जनपद बागेश्वर के अन्तर्गत बालीघाट-धरमघर-खन्तोली पुल से गुरगुच्चा प्रा0पा0 स्कूल तक मोटर मार्ग के निर्माण हेतु 0.63 है0 वन भूमि के प्रत्यावर्तन के संबंध में। (प्रस्ताव सं0- 12710/2015)

विषय:- जनपद बागेश्वर के अन्तर्गत बालीघाट-धरमघर-खन्तोली पुल से गुरगुच्चा प्रा0पा0 स्कूल तक मोटर मार्ग के निर्माण हेतु 0.63 है0 वन भूमि के प्रत्यावर्तन के सम्बन्ध में। (Online Proposal No. FP/UK/ROAD/12710/2015).

क्र0 सं0	ई.डी.एस. आपत्ति	उत्तरालेख
1	The State Government is requested to Submit a geologist report from a reputed institute in support of the proposed alignment	प्रस्तावक विभाग द्वारा प्रस्तावित समरेखण का प्रतिष्ठित संस्थान के भू-वैज्ञानिक से निरीक्षण कराकर भू-वैज्ञानिक रिपोर्ट संलग्न कर प्रस्ताव अग्रिम आवश्यक कार्यवाही हेतु प्रेषित किया जा रहा है।

Closer Satellite view of the site

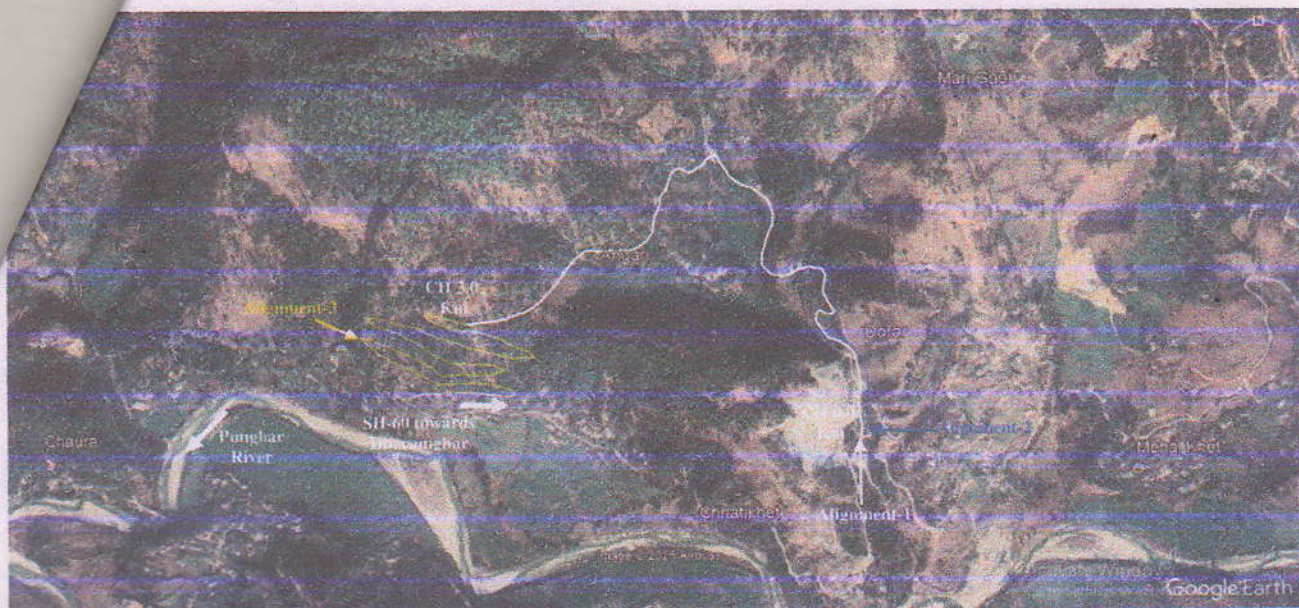
बिन्दु सं०	लगायी गयी आपत्तियाँ	आख्या
1	The State Government is requested to Submit a geologist report from a reputed institute in support of the proposed alignment	प्रस्तावित समरेखण का प्रतिष्ठित संस्थान के भू-वैज्ञानिक से निरीक्षण कराकर भू-वैज्ञानिक रिपोर्ट संलग्न कर प्रस्ताव अग्रिम आवश्यक कार्यवाही एवं सैद्धान्तिक स्वीकृति हेतु प्रेषित किया जा रहा है।

- 3- **Geological Assessment:** Geologically, the site area falls under Inner Lesser Himalayan region of Kumaon region in the vicinity of thrust contact between Deoban (in the West) & Berinag (in the East) formations of Tejam & Jaunsar groups respectively. Lithologically, the area consists of folded, jointed and fractured thinly laminated dolomitic lime stone, calcareous shale/slate, quartzite and slaty quartzite belonging to Deoban & Berinag formations of Tejam & Jaunsar groups respectively. However, the motor road alignment intersects the hill slope which is mostly draped with thick to thin cover of overburden (OB) which consists of slope wash material (SWM) over which there is cultivation fields (Naap khet & Civil land) and vegetation which predominantly consists of Pine trees (Forest land) with patches of folded & jointed bed rock.

Alignment-1 diverts from CH 59 Km of SH-60 near right abutment site of Khitoli motor bridge and turns left towards upstream direction of Kintoli gadera valley along the right bank slope (till 0.500 Km) after which the alignment crosses the gadera and moves along its left bank slope and further crosses the gadera at Km 02 finally ending near GPD Palson. The total length of the alignment is 3.0 Km and it does not have any hairpin bends. The gradient of this alignment is level to 1:20, 1:24 & 1:60 of rising gradient and 1:40 of falling gradient. This alignment has already been found geologically suitable by Mr. Vijay Dangwal (Ex. Senior Geologist, PWD) & Dr. Tushar Sharma (Geologist, PWD). Except that the alignment intersects an old muck dumping zone (initial ~50-100 m) for which suitably designed protection measures are to be taken. The advantage of this alignment is that it will connect Khitoli, Gurguccha, Dhapola, Kumaiyan villages ending near GPS Palson.

The hill slope of the alignment-1 site area is gentle to moderate to steep which declines at ~10-40° initially towards west direction followed by South-East & south-West direction. The approximate strength of exposed rock mass is around ~80-100 MPa and has undergone W_0 to W_3 weathering grade. It intersects 02 small perennial streams/naalas at Km 01 (~ CH 0.500 Km) & Km 02 which in the absence of scuppers/culverts/bridge may damage the motor road especially during monsoon season.
